SUBJECT: 2/25/20 Board Meeting: Independent Management and Oversight Report on the San Francisco Municipal Transportation Agency's Siemens Light Rail Vehicle Procurement

PROGRAM MANAGEMENT OVERSIGHT REPORT

SFMTA LIGHT RAIL VEHICLE PROCUREMENT

Exhibit 2 - Old Design – Brackets at same plane as bottom of APS

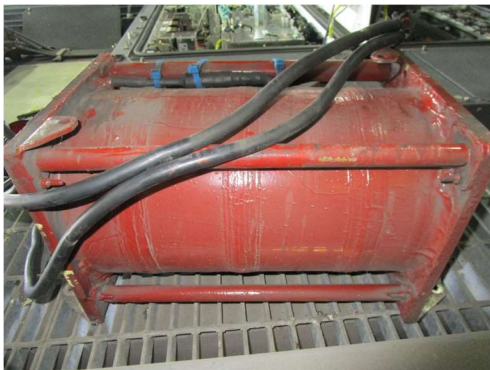
The root cause was determined to be the mounting of the APS unit. The APS unit brackets placed the bottom of the APS unit at approximately the same plane as the bottom of the compartment [Exhibit 2]. Therefore, water would accumulate in the compartment and not be able to get under/past the APS unit to the drain, splash into the APS and arcing would occur. The water volume, although minimal, was enough that during car movements the water would splash into the APS unit and the APS unit would fail. Note that the APS unit requires air circulation for cooling and is therefore not sealed from water.

In order to provide clearance for water to be drained underneath the APS, the mounting ears that were integral to the APS frame were removed and new brackets were designed and attached to the APS frame that slightly raised the APS off the floor of the APS line choke compartment [Exhibits 3 and 4]. The compartment provides for the additional APS height and the cover and car clearance are not impacted.

Exhibit 8 – Collector Assembly with Shunts and Nordlock Washers installed

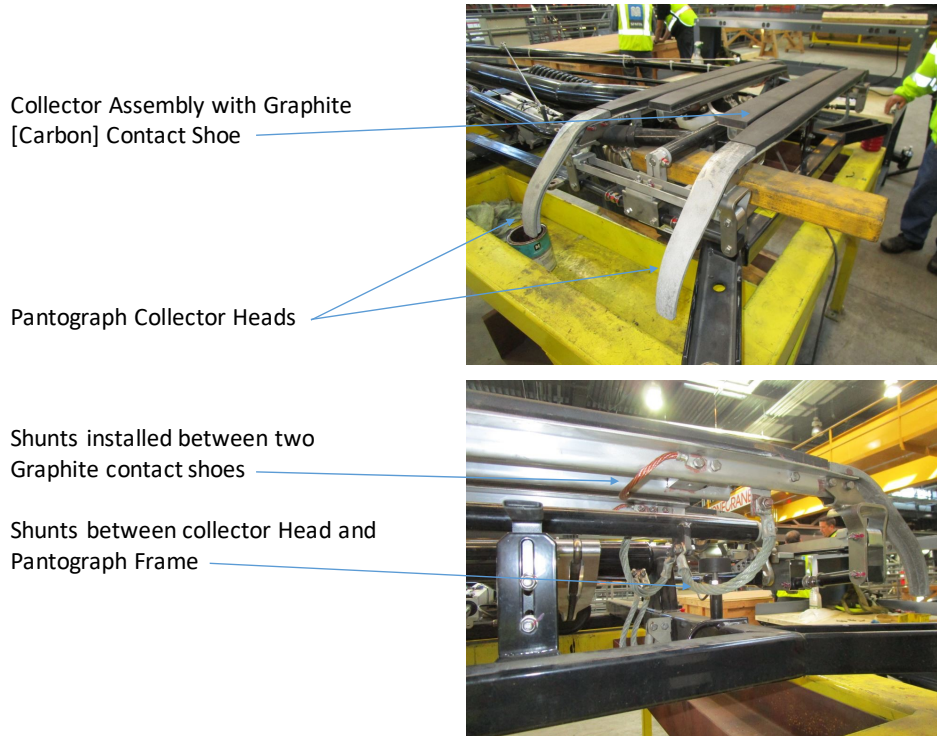
The failure occurred when energy moved through the slide plate mounting bolts that were installed using Nylock nuts. The nylon on the nuts failed because they overheated from the current, which resulted in a slide plate partially separating from the pantograph frame. Because the car was in a tunnel and the pantograph collector head was only two feet above the car roof, the slide plate touched the roof of the car causing a fault.

There were two root causes for this fault. First, hardware such as the Nylock nuts should not have been used in this application because the pantograph is fully charged. Second, in this application, the current should not be going through hardware but through shunts. Shunts are devices such as cables that provide a low resistance path for electric current.

Although there was only one such failure in the system, because of the severity of the failure and the potential to damage not only a car but also the catenary, all Nylock nuts on the pantographs were replaced with metal Nordlock washers and standard nuts. Also, eight (8) shunts were installed on each pair of collector heads to direct the path of the current from the graphite collectors and blocks through the shunts to the pantograph arms, thereby moving the current around the mounting hardware.

The solution has been tested and approved by the Safety and Security Subcommittee including CPUC. All pantographs have since been modified, as a Siemens warranty repair, and the issue is closed.

Exhibit 9 – Fingers shown on door pinch point

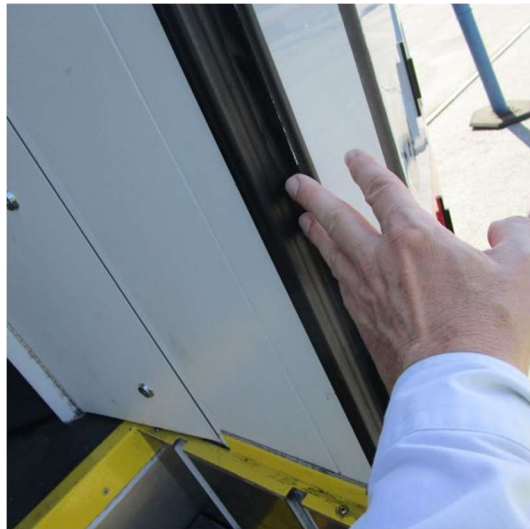
The door design with only one sensitive edge strip left a gap at the interlock point when the door closes where an object or hand could be pinched. [*Exhibits 9 & 11*].

It was determined that if additional sensitive edge strips were incorporated both in the gap where the pinch point existed and on the edge of the door [*Exhibits 10 & 12*], any object in the path of a closing door would be detected and reverse the door's operation.

Exhibit 11 – Sketch of Original Door Design

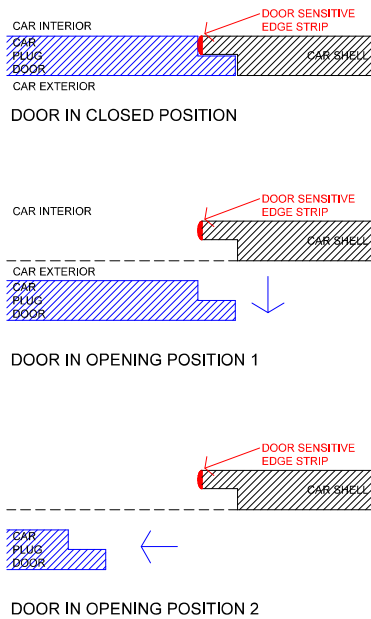
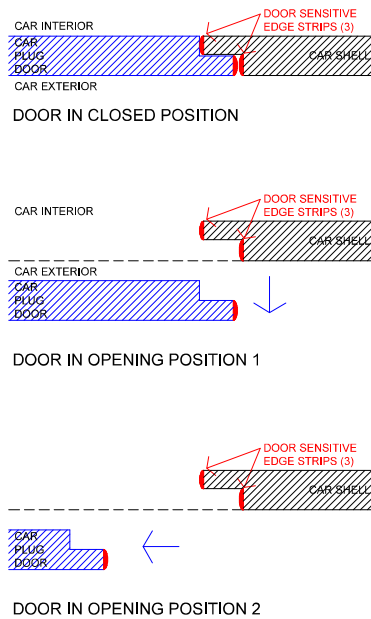
In the original design there was one sensitive edge strip installed on the door frame that is attached to the car body [Exhibit 11]. The strip was the full height of the door. When touched by an object or person when the door is closing, the pressure on the strip signals to door to stop and reverse back to the open position.

All cars have now been modified with the three-strip approach as a Siemens warranty item. The fix was monitored and approved by the SFMTA Safety and Security Committee. This committee has been directly involved with overseeing the vehicle commissioning process and includes representatives from multiple SFMTA departments. The California Public Utilities Commission (CPUC) also participates in these committee meetings where the fixes are reviewed and approved through the safety certification process. The issue is now closed.

Exhibit 14 – Lateral Stop and Upper Clam Shell Damage

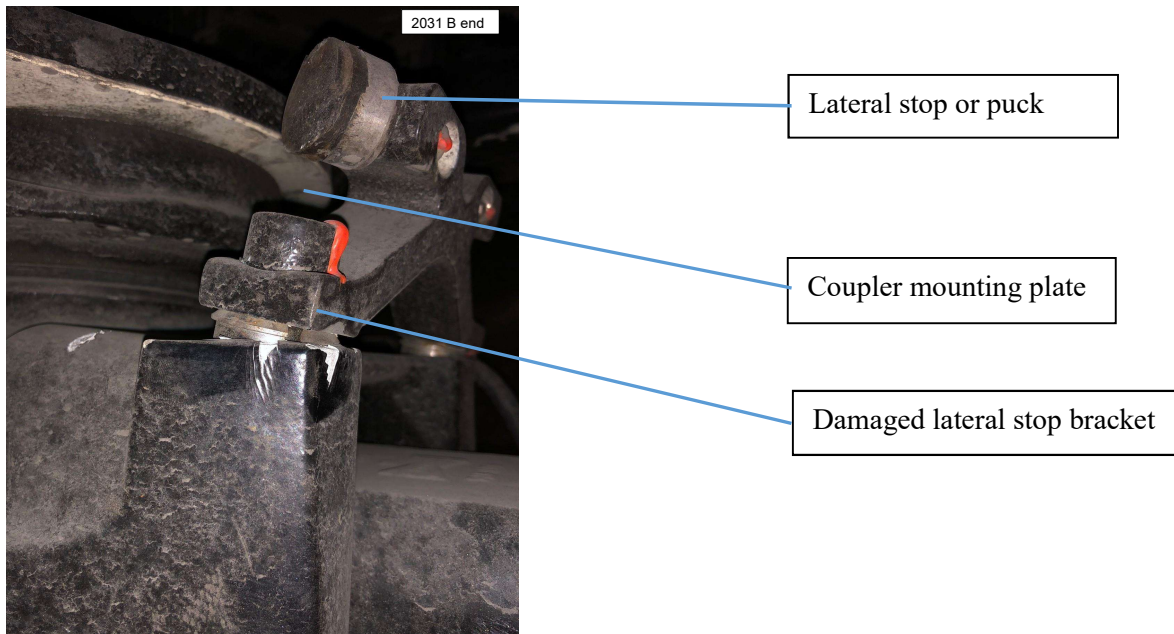
The only unusual variable that appeared in the inspections is that the lateral stop bracket, which limits the coupler horizontal swing during maintenance had been damaged and partially detached [Exh. 14]

Exhibit 14 also shows that the rubber piece on the stop, which is called a puck, is larger than the lateral stop bracket and is at the height of the coupler mounting plate. Note also that the coupler mounting plate, which is part of the car not the coupler, extends beyond the coupler assembly, which mounts to the plate.

Second, the 2mm clearance between the lateral stop bracket puck and the coupler mounting plate was deemed insufficient. Therefore, because the stop bracket is only a bump stop to keep the coupler from damaging car underframe parts when a maintenance worker swings the coupler out of the way for servicing the car, a smaller diameter replacement puck that would not extend beyond the height of the lateral stop bracket would be adequate [*Exhibit 17*]. This would increase the clearance between the puck and the mounting plate to 7mm.

Exhibit 15 – Cross Section through Coupler Bearing Housing

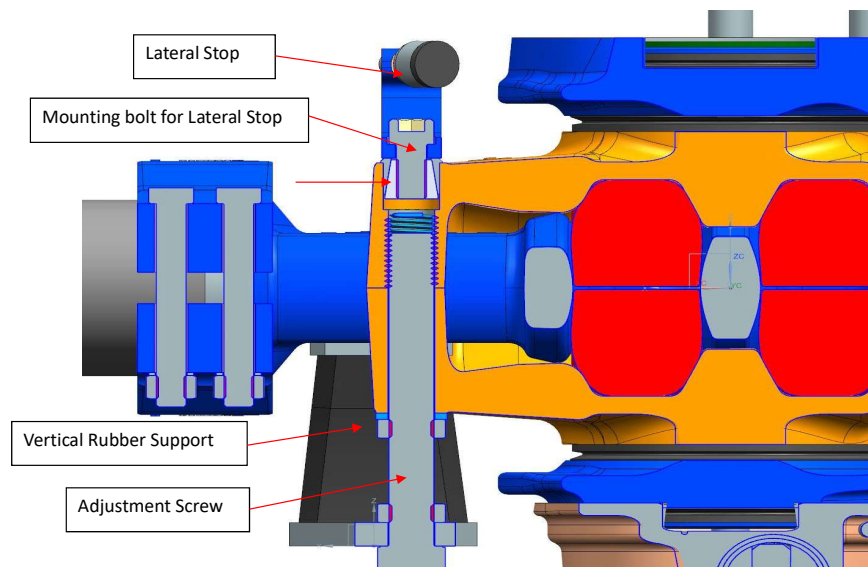
Further investigation into the engineering of the stop bracket mounting determined that the mounting bolt for the lateral stop bracket and the adjusting bolts for the coupler inclination occupied the same hole. If the coupler adjustment bolt was over tightened, compressing the rubber vertical support, the bolt would push the mounting bolt for the stop bracket out. With only 2mm clearance available between the puck and the coupler mounting plate, this was determined to be the root cause for the failure of the coupler.

Third, in order to prevent the adjustment screw from being over tightened due to, for example, not coupler height but wear of the rubber support, a sleeve spacer was installed on the Adjustment Screw to prevent the Adjustment Screw from being tightened such that it engages and pushes the mounting bolt for the lateral stop out of the clamshell [Exhibit 18].

Exhibit 22 - LRV4 Projected MDBTF

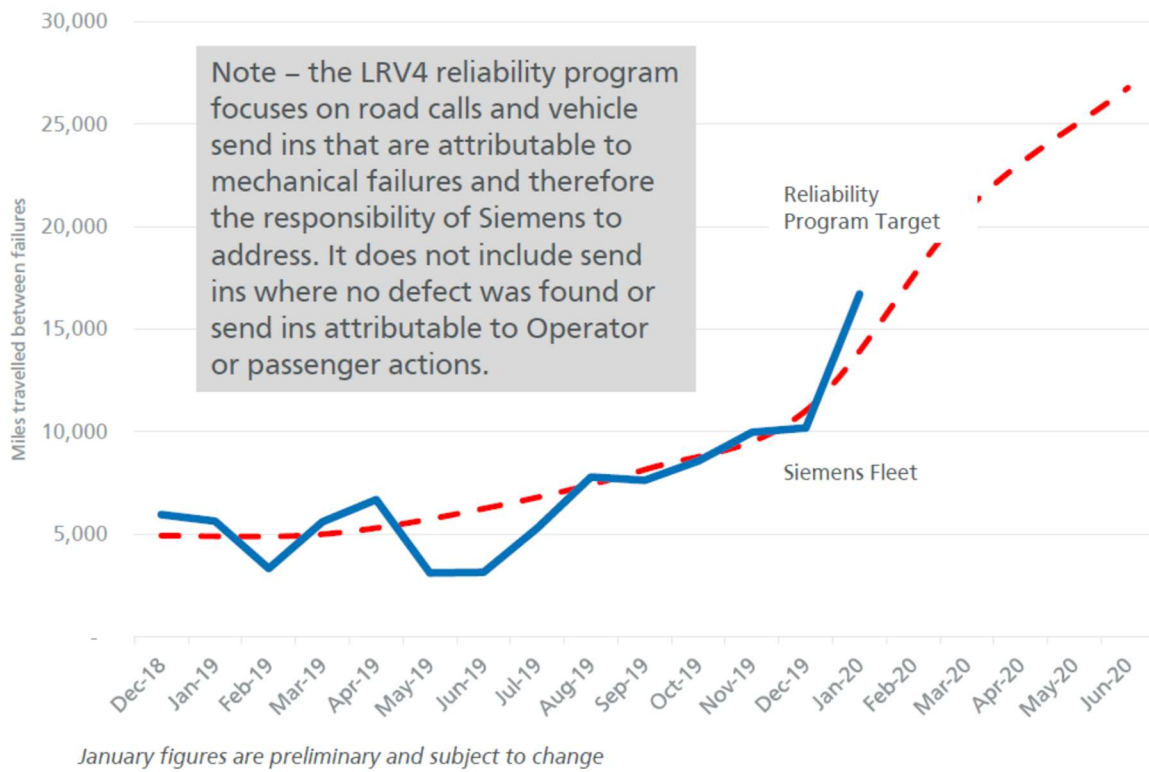
The MDBF calculations depend on two factors, mileage traveled and recorded failures. Siemens is contractually required to provide an MDBF of 25,000 miles. And yet, the MDBF for the LRV4s at the start of service was approximately 5,000 miles. By January 2020 the MDBF had improved to approximately 17,000 miles [*Exhibit 22*]. By comparison, the current Breda fleet had an MDBF of 3,300 in FY 2003, which dropped to under 2,000 miles in FY 2005. Ultimately the MDBF increased to a high of 5,500 miles in FY 2006. The calculation of MDBF for the existing Breda fleet is based on a different assumption regarding chargeable failures. The Breda calculation includes many non-mechanical failures including (train control, operator caused, customer caused) that are beyond the control of Siemens and therefore not included in the LRV4 MDBF calculation requirements.

The MDBF trend for the LRV4s is calculated on a monthly basis by Siemens and reviewed by SFMTA staff and their Failure Management Board. This information is reviewed to identify trends and any particular causes for changes. For example, the MDBF was positive at the end of 2018, but in February of 2019 then took a negative hit for the APS faults. It was the rainy season and a number of APS units failed from excess water in the APS Line Choke Compartment. This also impacted availability and mileage as all car APS units needed to be modified with the temporary solution. Once corrected the trend was again positive. In May the MDBF took another negative hit for both the couplers and the doors. And even though there was only one recorded failure for each, the repairs were required on all cars, which impacted availability and mileage. The continued flat spotting of the wheels is not considered a failure, but it does impact MDBF in that it impacts the availability and mileage put on the LRV4 cars.

4. The contract be amended to clarify MDBF attainment and clarify consequences of non or delayed attainment (retention, partial hold on SFCTA funding) of the contractual requirement.
